# ***SERVICE INFORMATION BULLETIN***

**SUBJECT:** Pulse Pump Hose Line Routing Inspection

**MODELS AFFECTED:** EcoGen Model 5818-1 Serial Numbers 7995894 to 8176897

**Figure 2. Yellow X - Pump is OK**

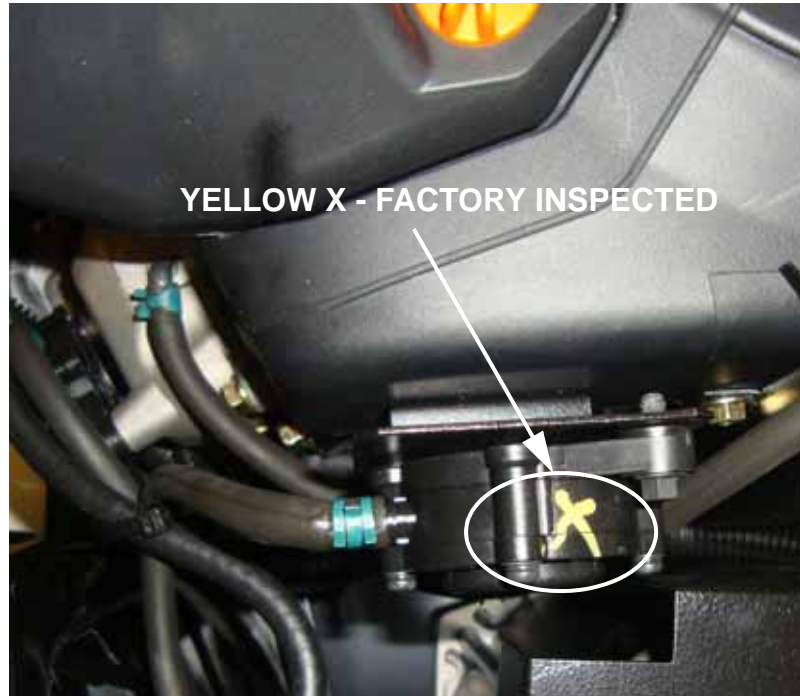
3. If the top of the pulse pump has a yellow X, it has been factory inspected and all hoses have been routed correctly. No action required. See Figure 2.

**Figure 4. Pulse Hose Routed INCORRECTLY**

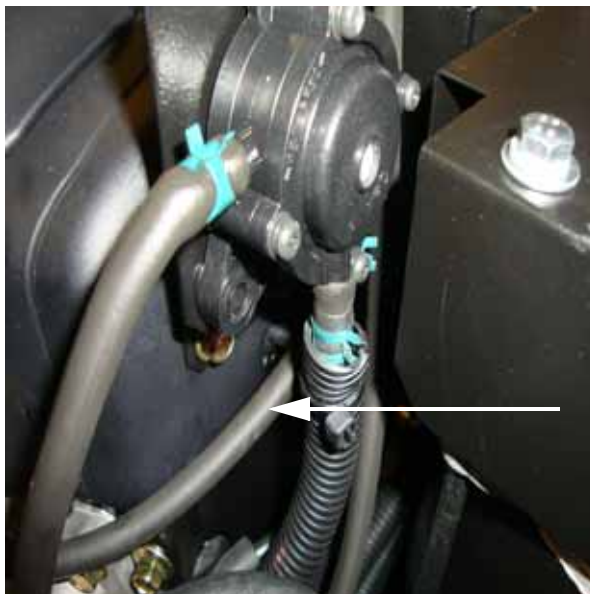
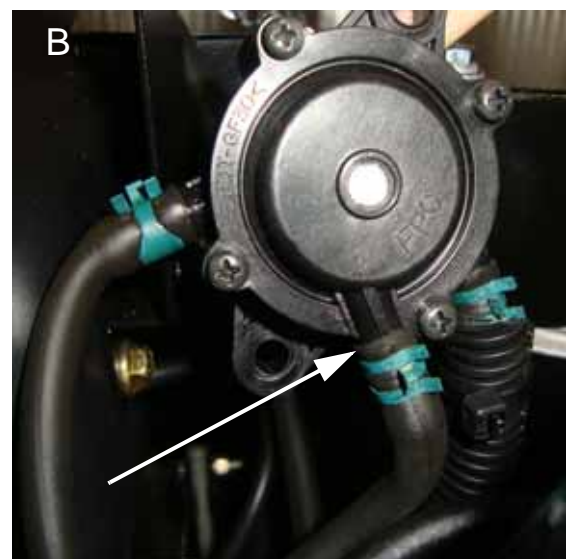
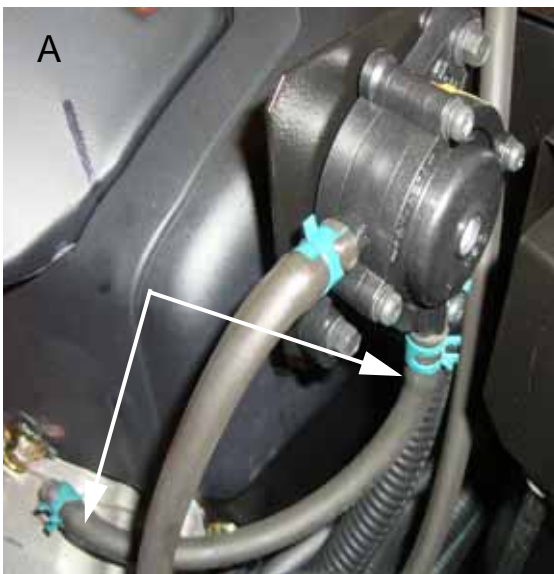
**PROBLEM:** It is possible that the hoses are connected incorrectly. This can cause the crankcase to fill with excessive amounts of oil.

5. See Figure 4. Pulse Hose is routed INCORRECTLY.  
Change the locations of the hoses at the pulse pump fittings as shown in Figure 3.
6. Reconnect battery cables, positive (+) red first. Install the 7.5 Amp fuse.

4. If there is no yellow X, inspect to see if the hose routing is correct or not. Figures 3 A&B show the CORRECT routing of pulse hose at the pulse pump.

**Figure 3. A&B Pulse Hose Routed CORRECTLY to P port**
